**STAFF REPORT: AUGUST 14, 2024 MEETING**

**APPLICATION NUMBER: HDC2024-00381**

**ADDRESS: 3747 TYLER**

**SCOPE: INSTALL VINYL WINDOWS\* (WORK COMPLETED WITHOUT APPROVAL), ALTER PORCHES**

#### Option Two – four equal-sized window openings - #2 Back Façade – Prop Op 1

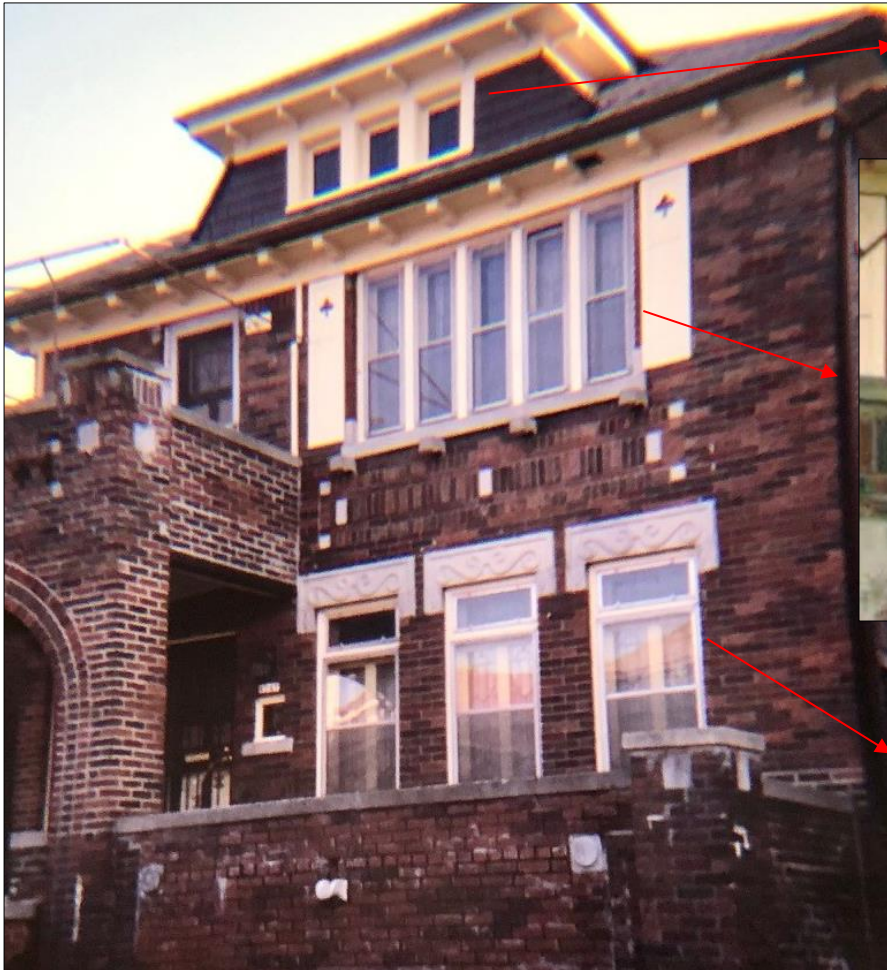
- This proposal offers a somewhat permanent change to the door opening, by its solid enclosure, relocated stone threshold/sill and installation of brick. This option doesn't offer any difference in the internal use of the four windows but is significantly more destructive to the exterior wall and historic openings.

*Left: Staff photo, July 26, 2024. This condition of the soffit and fascia has been in place since at least September 2021 when staff first photographed this property.*

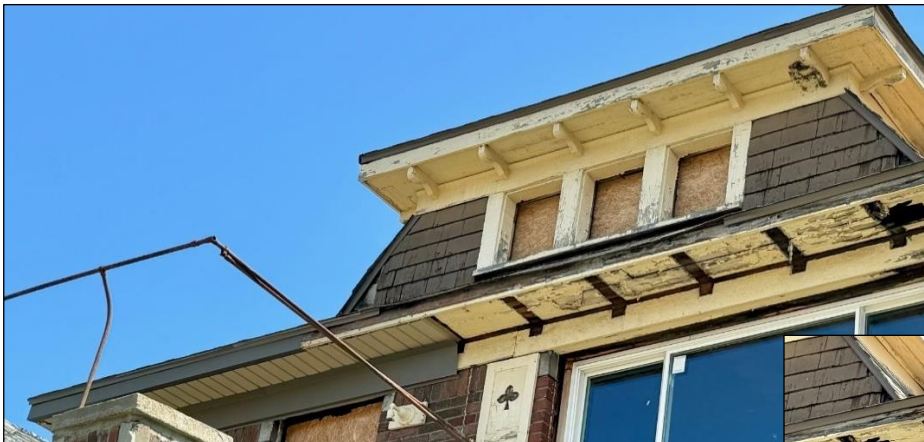
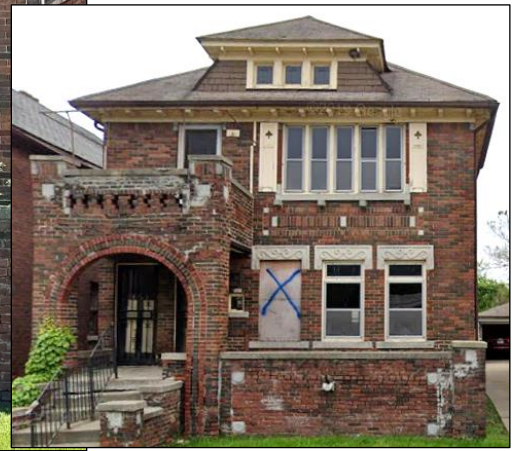
- This property is subject to the Detroit Land Bank Authority’s (DLBA) Nuisance Abatement Program (NAP), which required the property owner to rehabilitate the house. However, the rehab work was undertaken without HDC approval.
- Additional work identified which is NOT included in this application - the partial removal of the soffit brackets and covering of the wood soffit and fascia. This work occurred between June 2019 and September 2021.

### Applicant drawings

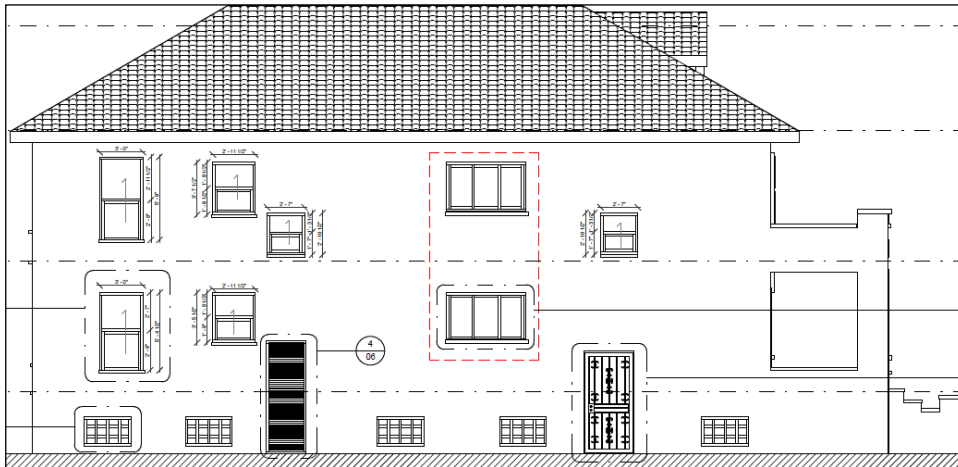
- Aluminum-clad wood single-hung windows, suggested at the second floor to replace the vinyl slider/fix window, do not match the operation (nor the glass details) of the historic leaded glass mulled casement windows. Additionally single-hung windows are not adequate replacement of double-hung windows due to the stationary upper sash being welded to the window frame.

- The installation of aluminum-clad window frames positioned in front of vinyl single-hung windows at the first floor will not replicate the removed windows (which were double casements with mulled transoms). As shown in older photographs, the first and second floor casement windows created a strong vertical pattern that emulated the vertical proportions of the 1-1/2 story masonry porch entry.

- If the Commission considers not requiring that new leaded glass windows be fabricated for the front elevation opening, it is staff's opinion that at a minimum, the window operations and details must be matched, which means the first and second floor would have casement units as well as the additional mulled transoms at the first floor.

**Right- West Side Wall**

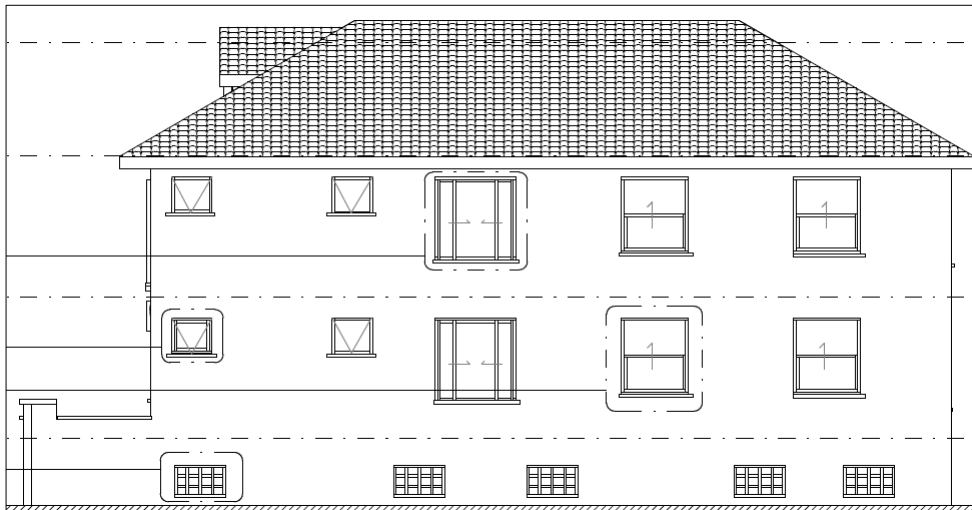
- Similar to the other side wall, the taller than wide openings will receive new single-hung vinyl windows covered with aluminum-clad wood frames as shown in this drawing. The four small windows will retain the existing wood window frames. The tall central openings will receive new vinyl sliding units covered with aluminum-clad wood frames.

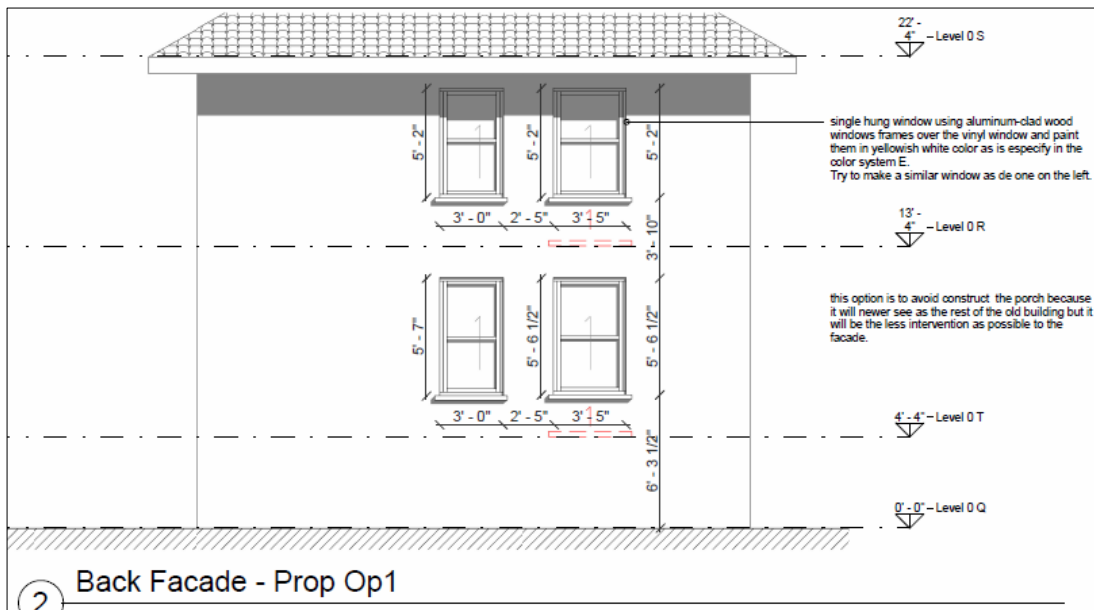
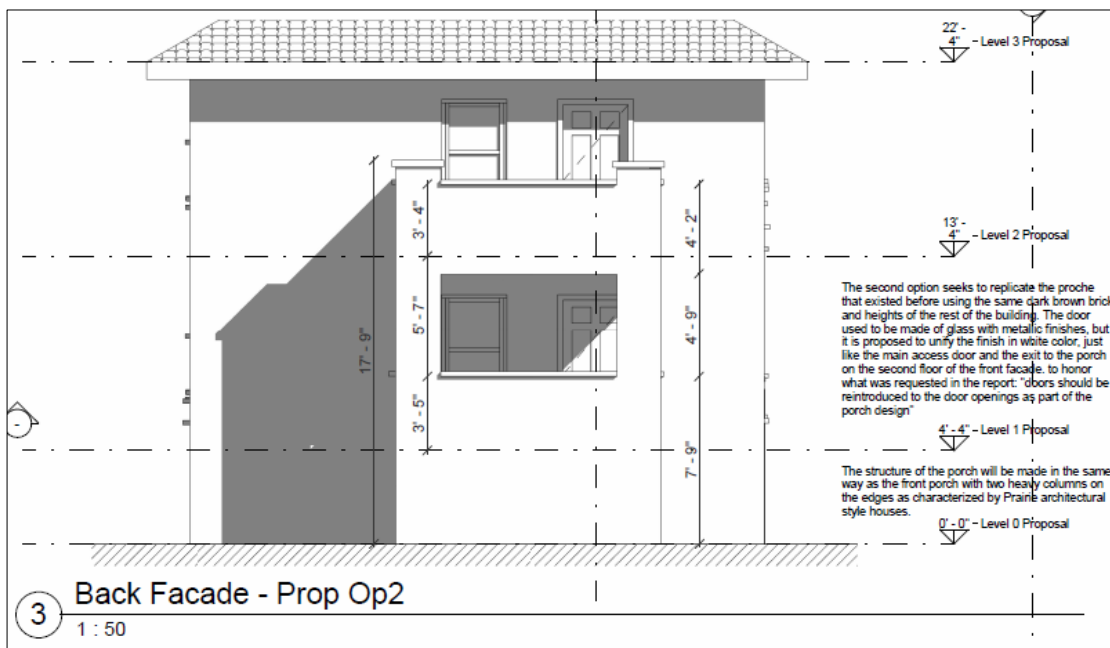
- Within this application, the applicant proposes to install an identical metal panel at the second floor door opening.
- As these openings are on the rear elevation, are not part of the public view, and don't remove distinctive features, it is staff's opinion this alteration to the door openings falls within Standard #10: *New additions and adjacent or related new construction shall be undertaken in such a manner that if removed in the future, the essential form and integrity of the historic property and its environment would be unimpaired.*
- Staff's comments relate only to the generalized scope of work at this elevation – the existing windows and wrapped brick mould are not part of staff's supportive review of this option.

- This option retains the functional door openings but creates a non-historic element at the rear of the house. The ghost images of the wood railing shows that a masonry porch was not in this location. The opulence of the details that were designed for the front public-facing wall, including cast concrete window hoods, highly decorative leaded glass windows, larger dormer and full width front porch, is quite different than this relatively unadorned private, rear-yard facing elevation. The erection of two story masonry porch is akin to Standard 3 which says, "Changes that create a false sense of historical development...shall not be undertaken."

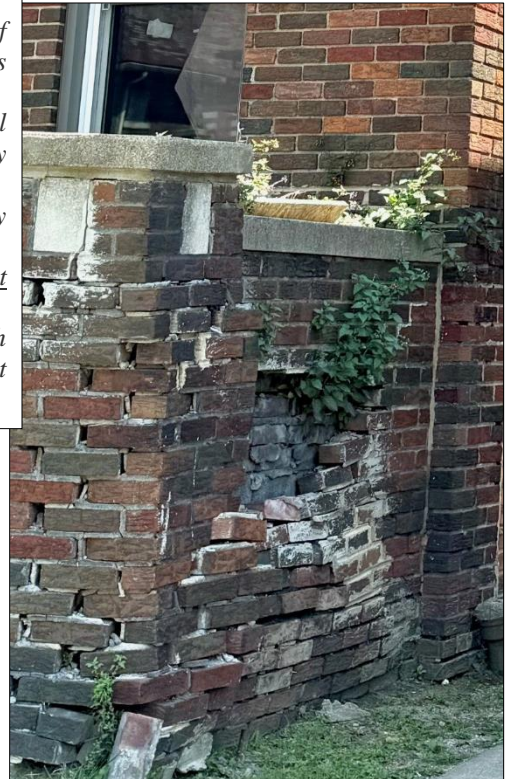
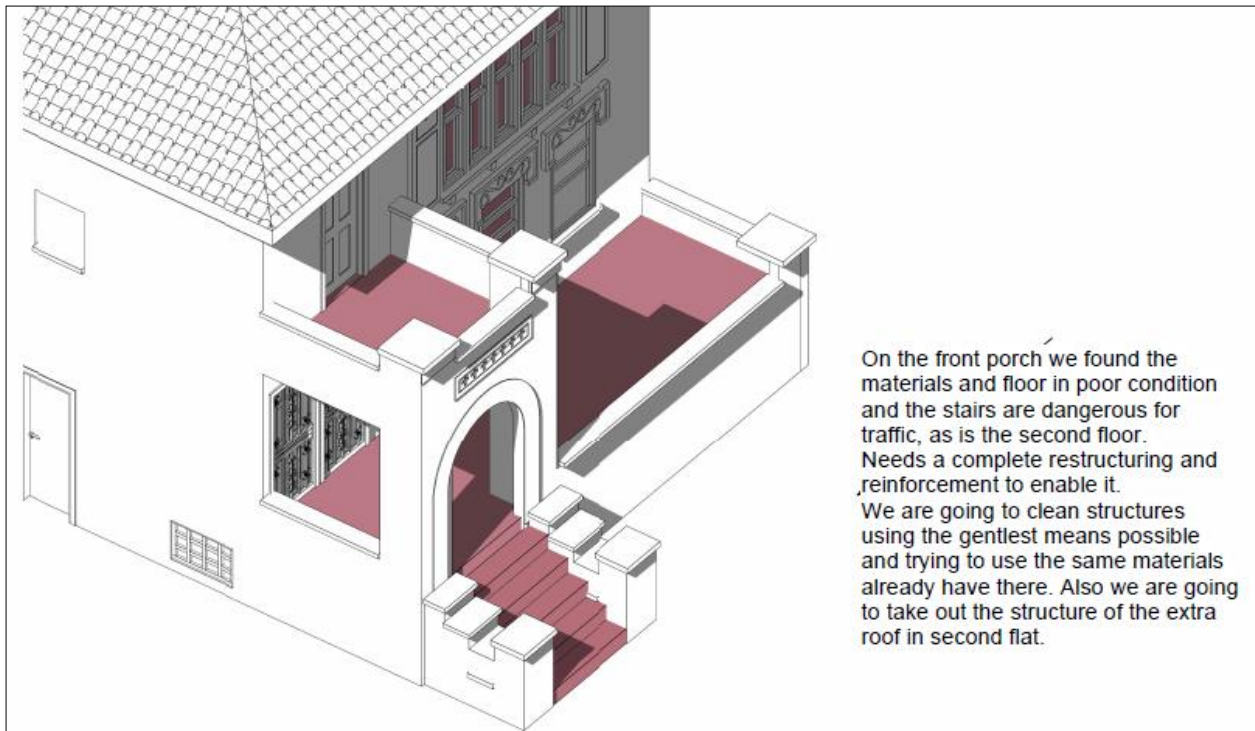
- The applicant proposed to rebuild portions of the front elevation's masonry porch. Based on the photos and staff's site visits, a high level of deterioration, some structural as well as masonry deterioration due to poorly executed tuckpointing, is evident.

- The applicant’s condition assessment is not fully documented, and the scope of work is not detailed to the level needed, in order to clearly understand the areas of concern as well as the construction methods that will be used to repair this porch.

- Dimensioned drawings confirming the historic design and construction are needed, as is additional pictorial and written description of existing conditions.

- Detailed processes to embark on, such as “clean structures using the gentlest means possible” need to be fully explained, including method, material and pressure of cleaning proposal.

- If a section of the existing porch is to be deconstructed and rebuilt (like possibly the outer, east masonry pier which isn’t identified in the current scope of work), a dimensioned drawing confirming how it will be reconstructed is required.

- Assuming that some new brick may be needed, on this porch or the house, brick samples that closely match the existing brick in dimension, color, pattern, finish and profile will be submitted to staff for review against the historic brick. Also, specification of the new mortar, including composition and installation dimension, profile, etc. must be submitted to staff for review.
